PCN/22/012/C+N-US
Product Range: Han-Modular®

Title: Han 200A Module Axial Screw mating side

Details of the Product Changes

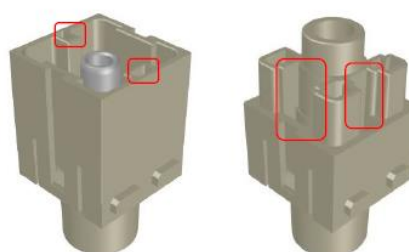
Improvement of the Han® 200A module axial screw mating side ensures mating compatibility with all other 200A and 300A modules.

The modified 200A axial module will also be backwards mating compatible with the present 200A axial module.

The changes are marked red at the below drawings.

The new 200A axial screw male module will get some additional depending, marked red.

Additionally, some outer edges will be smoothed a little to improve the handling.
